GENERAL ELECTRIC

MFN-096-80

SUBJECT: ADDITIONAL INFORMATION CONCERNING NEDO-24708

Reference: Letter from D. F. Ross to T. D. Keenan, "Request for
Additional Information Concerning NEDO-24708,"
November 6, 1979

FIGURE III.2-3; CRITICAL POWER AT NEGATIVE MASS FLUXES

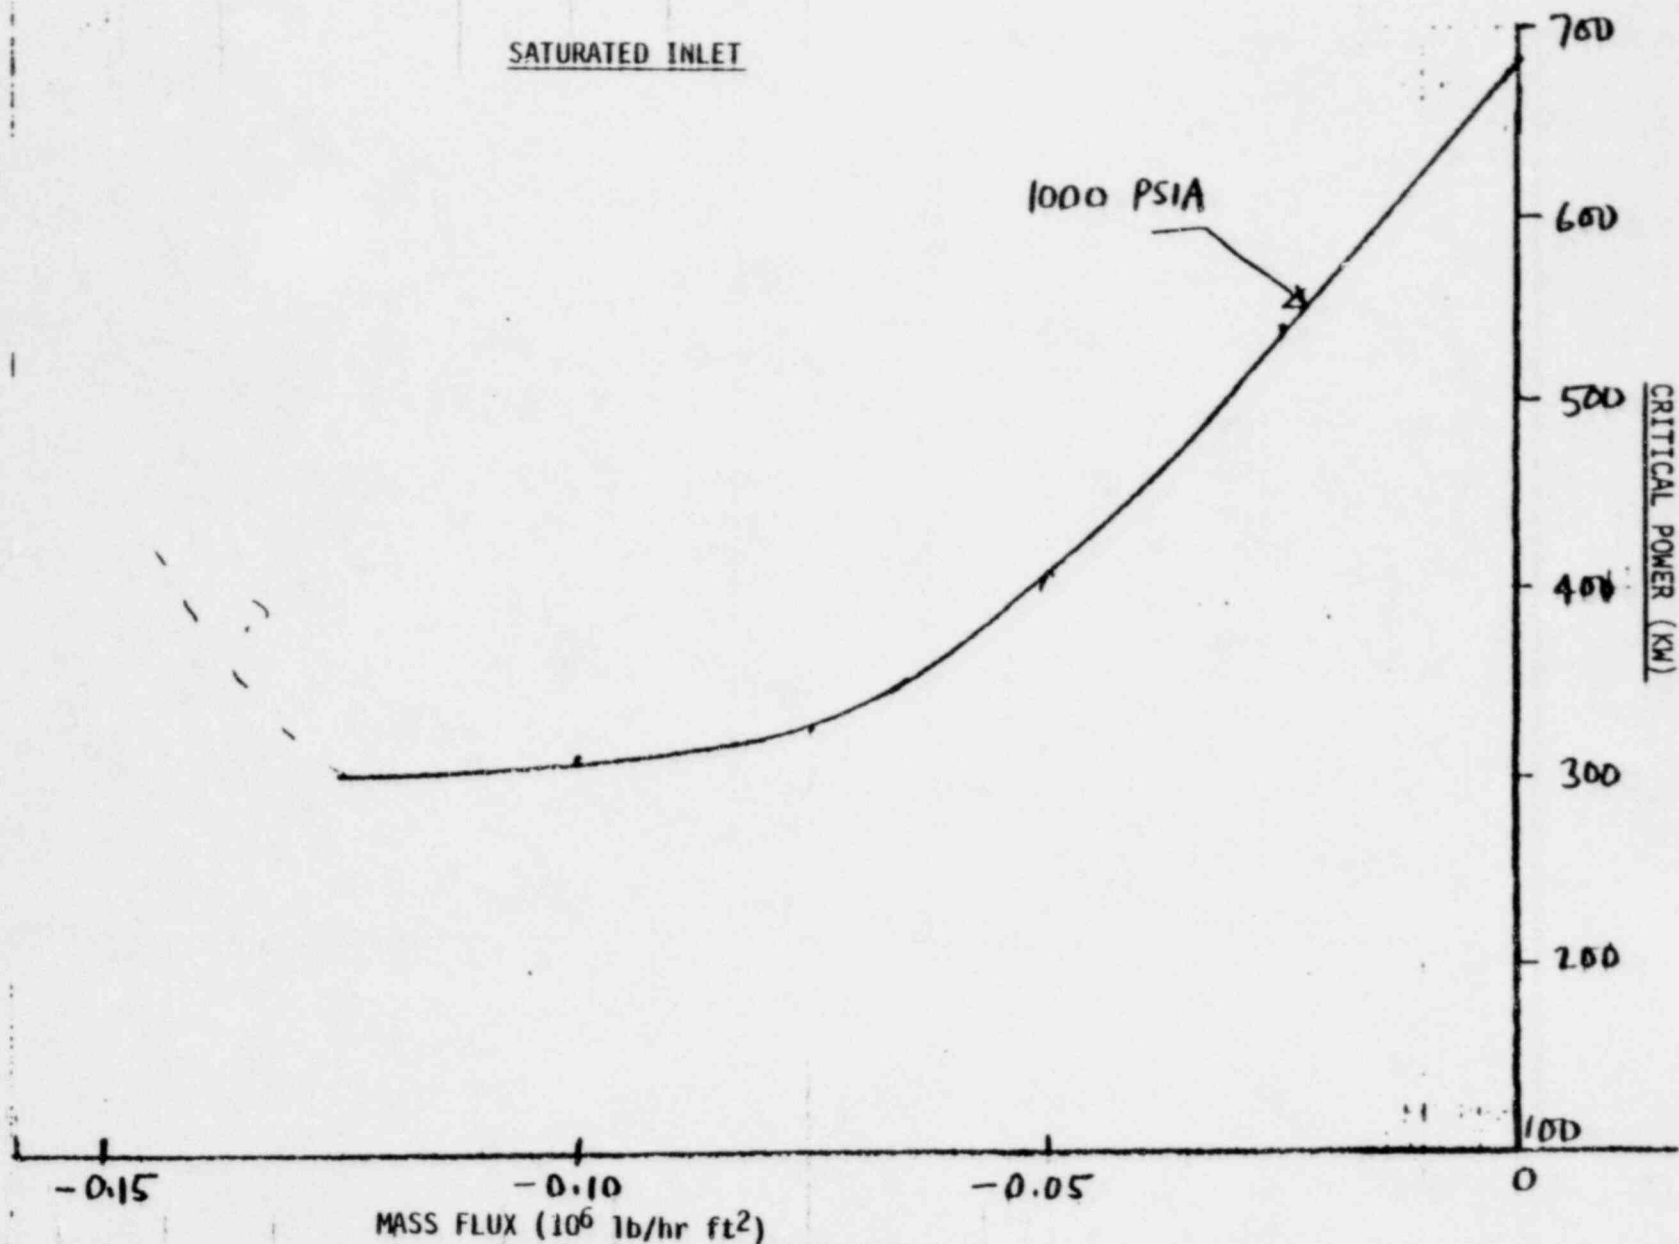
QUESTION III.2. Section 3.3.1.3 addresses the need for natural circulation in a BWR. In that section, reference was made to an experiment which showed that no dryout will occur, even at zero inlet flow, provided water is available in the upper plenum. Document the experiment, provide a graphic description of the experiment, discuss what break size will result in loss of upper plenum inventory within 10 seconds of scram, and the applicability of the experimental geometry to all operating BWR plants.

Figure III.2-3 shows a more detailed plot of the downflow and zero flow data. A range of pressure from 1000 - 300 psia showed a relatively small effect on the critical power. At zero net flow, the critical power is of the order of 650 - 680 KW. For net downflow (negative core flow), the critical power drops and levels out at about 300 KW for a downflow mass flux of 0.125×10^6 lb/hr-ft² at 1000 psia. At larger downflows the critical power would be expected to increase.

FIGURE IV-1.1.1

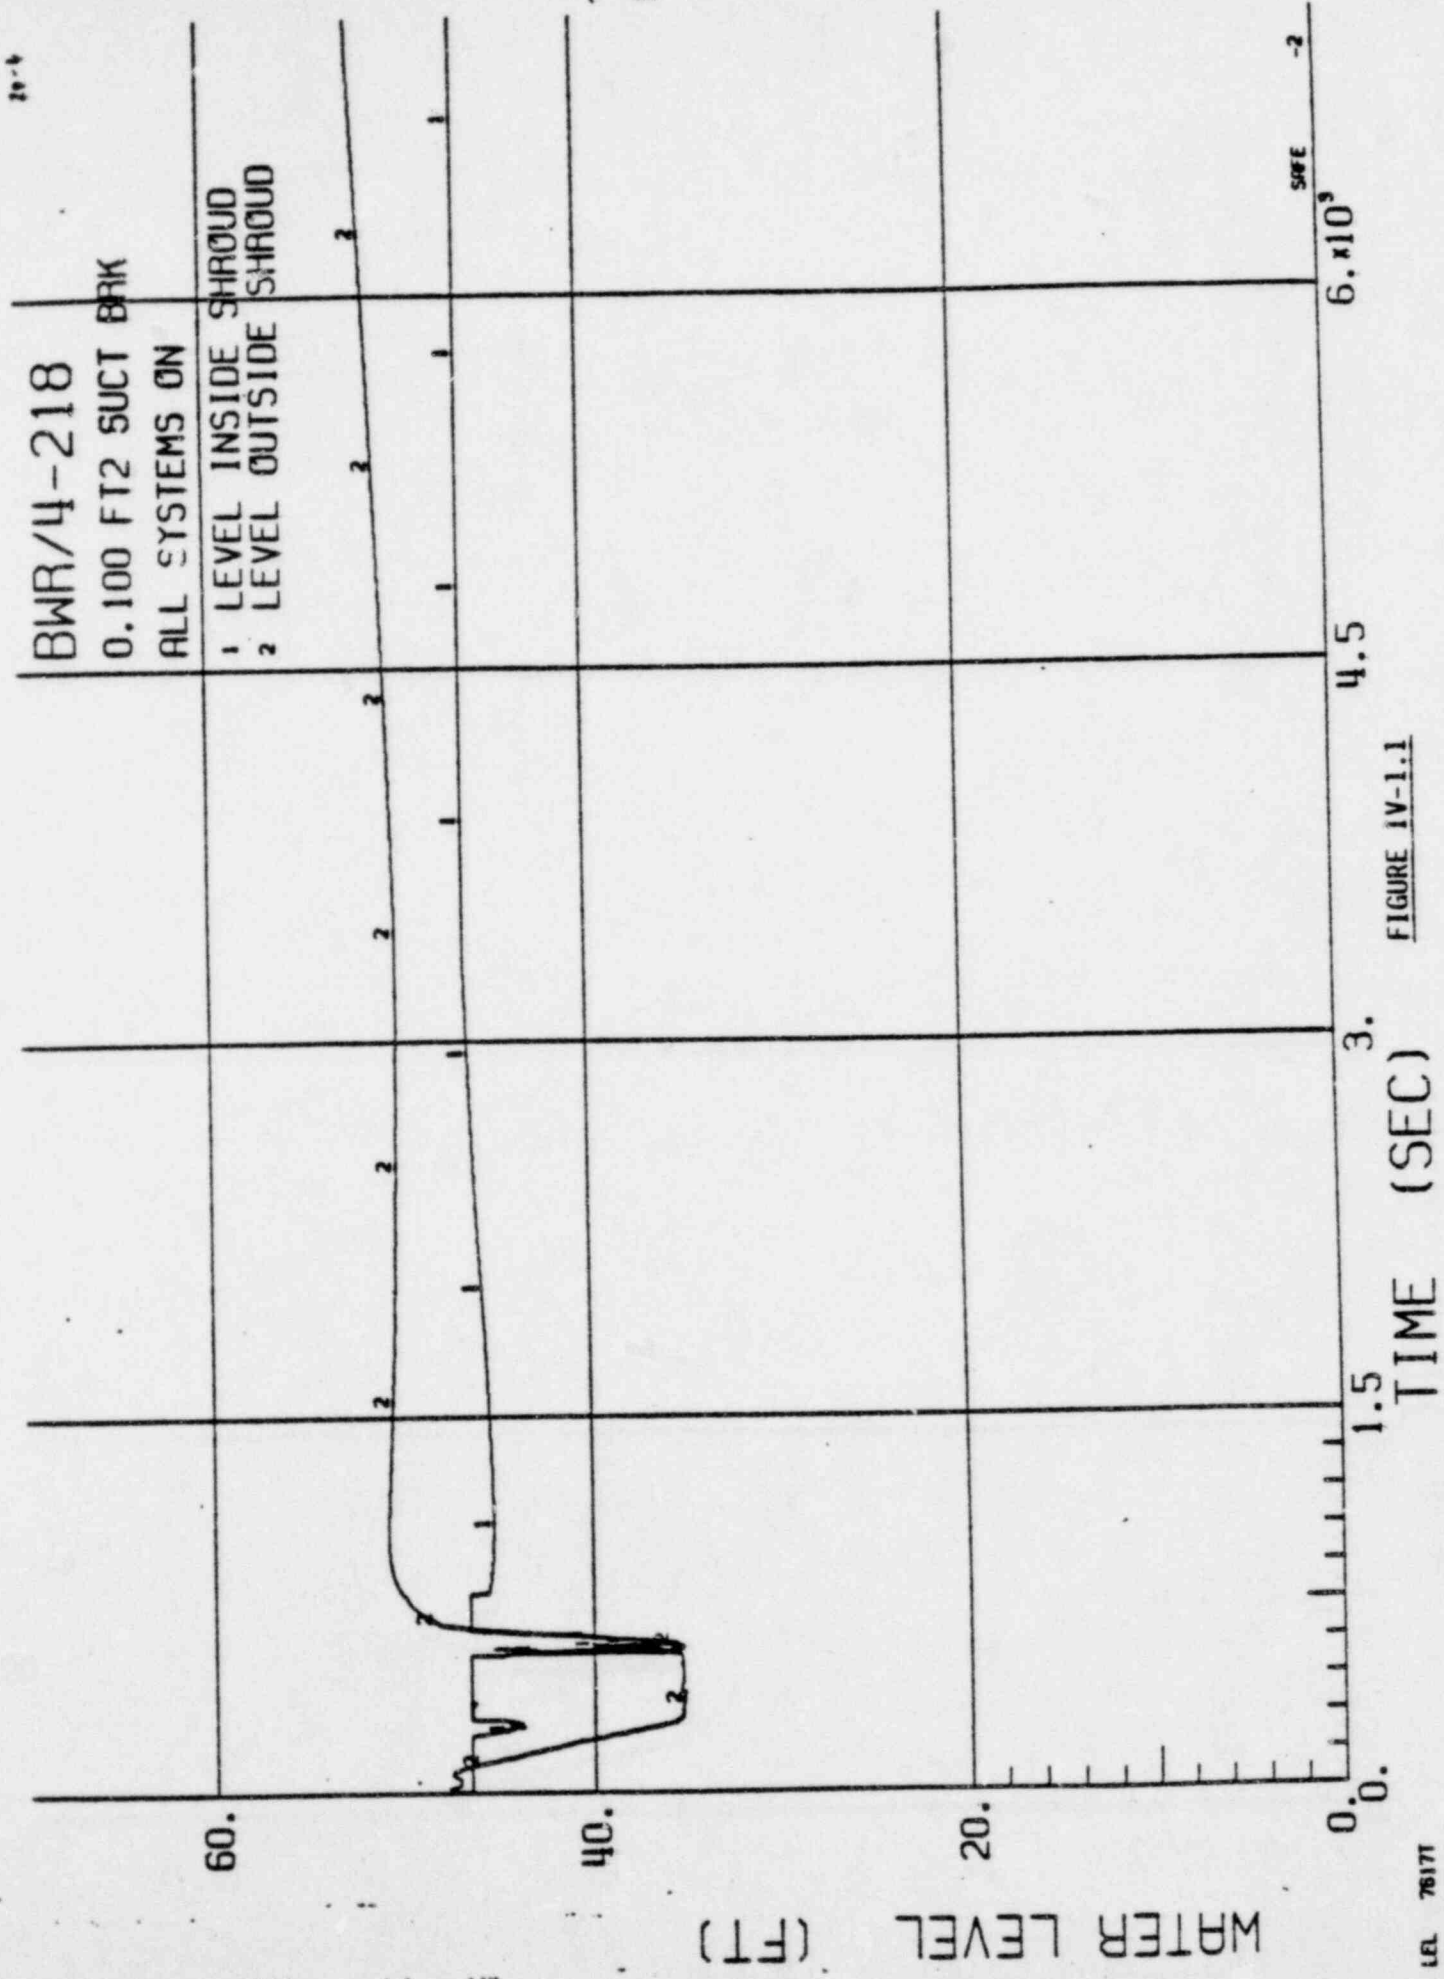
QUESTION IV.1. Analyses conducted utilizing the SAFE computer code showed numerical instabilities or non-convergence in evaluating model level and flows: i.e.

Figures 3.1.1.1-19.2
-19.5
-20.2
-20.5
-47.5, etc.

Discuss, in detail, the reasons for these oscillations and verify their impact on the analytical results. Are inertial effects accounted for in the analytical equations? If not, how does the neglect of inertia influence the system response? Verify that the code has converged to a solution for the analyses performed.

The water-level oscillations in Figures 3.1.1.1-29-2, -20-2, etc. occur because when vessel level has restored to the "spillover" region of the steam separators, the SAFE model assumes saturated rather than subcooled conditions. To demonstrate this, the discrepancy in spillover specific volume was corrected so that a consistent specific volume for the upper vessel liquid was used. The results of the new calculation are shown in Figure IV-1.1. In this figure the level inside the shroud is seen to rise to the spillover elevation of the steam separator and no oscillations occur.
